SUBJECT: SOUTH TEXAS PROJECT, UNITS 1 AND 2 - AMENDMENT NOS. 63
AND 52 TO FACILITY OPERATING LICENSE NOS. NPF-76 AND NPF-80
(TAC NOS. M89050 AND M89051)

The amendments modify Figure 3.4-4, "Nominal Maximum Allowable PORV Setpoint for the Cold Overpressure System," for the cold overpressure mitigation system with a revised setpoint curve.

SAFETY EVALUATION BY THE OFFICE OF NUCLEAR REACTOR REGULATION

SOUTH TEXAS PROJECT, UNITS 1 AND 2

FIGURE 3.4-4

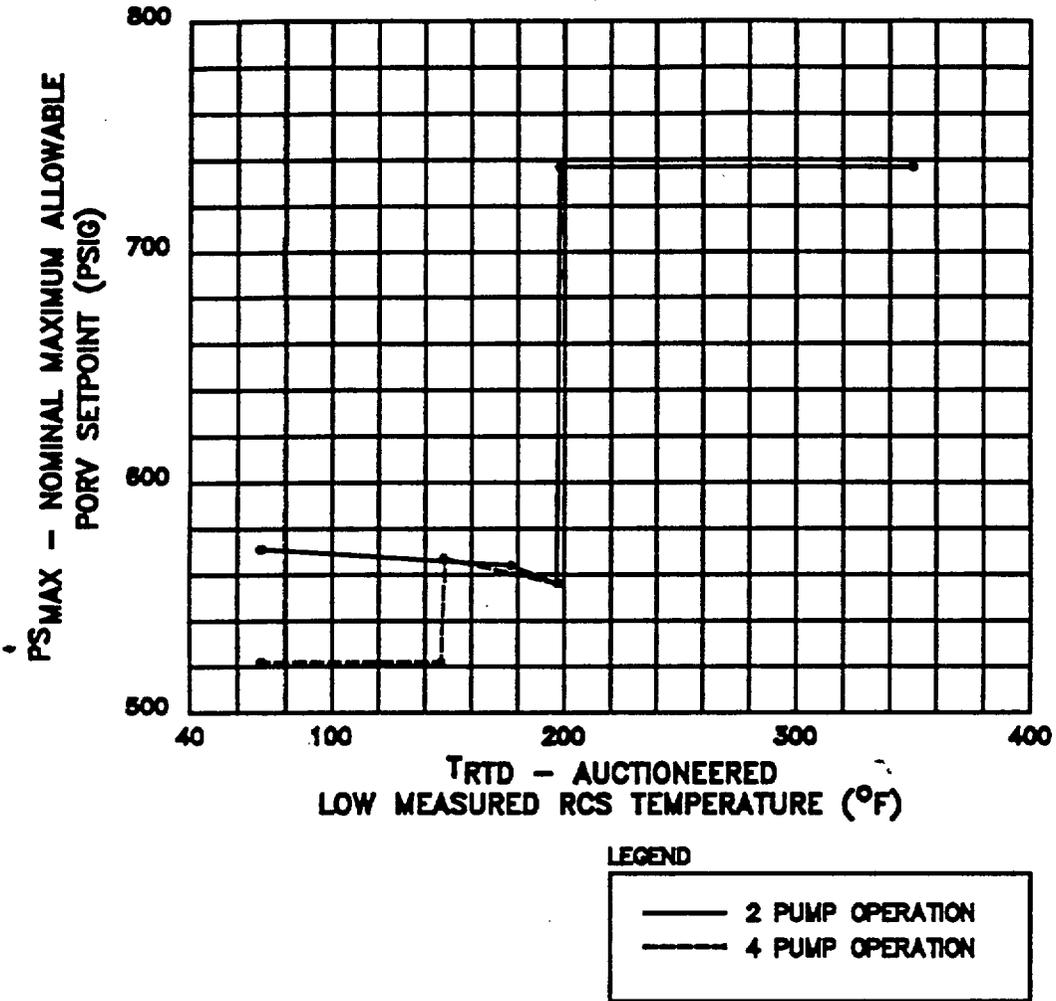
By letter dated March 16, 1994, Houston Lighting and Power Company submitted an application to modify TS Figure 3.4-4 (for PORV setpoints). The proposed changes incorporated corrections for a nonconservative item in the original setpoint study. The methodology used in developing the modified TS Figure 3.4-4 is provided in WCAP-13782, Revision 2, "Setpoint Program Determination for the Westinghouse Cold Overpressure Mitigating System in the Houston Lighting & Power, South Texas Units 1 and 2," dated February 1994. The new PORV setpoints provide protection against a potential overpressurization during low temperature plant conditions with either two or four reactor coolant pumps (RCPs) in operation.

By letter dated March 16, 1994, the licensee proposed a change in the PORV settings. This change was proposed by the licensee as a corrective action in response to a nonconservative item that was discovered in late 1992. This nonconservative item is that the pressure difference between the wide range pressure sensor and the reactor vessel location where the Appendix G limit is applicable, was not taken into account in the calculation of limits. This pressure difference effectively results in the pressure in the reactor vessel being greater than that seen by the wide range pressure transmitters, and therefore potentially resulting in violation of the Appendix G limit during a transient. Shortly following the discovery of this, the licensee implemented a temporary correction by lowering the PORV setpoints by 35 psi with only two RCPs in operation during low temperature operating conditions. The licensee has recently performed reanalysis to determine the correct PORV setpoints for either two or four RCPs in operation. The methodology used for developing the new setpoints is documented in WCAP-13782, Rev. 2. Heatup and cooldown curves for isothermal conditions and without instrument errors, applicable to 32 EFPY, were utilized for the Appendix G limit. The calculation associated with the Appendix G limit is documented in Appendix A of WCAP-13782, Rev. 2. The licensee considers that the use of isothermal curve for developing PORV setpoints is appropriate since the majority of the past overpressure transients were occurring during isothermal conditions. The staff agrees with this assessment in developing the new PORV setpoints. Both mass input and heat input overpressure transients are considered, which are consistent with the assumptions made in the previous setpoint study.

The licensee's proposed changes in TS Figure 3.4-4 reflect the changes discussed above. The staff has reviewed the licensee's submittal and finds that the changes are based on applicable regulatory guidance in Standard Review Plan 5.2.2 (Revision 2), are reasonably conservative, and are acceptable.
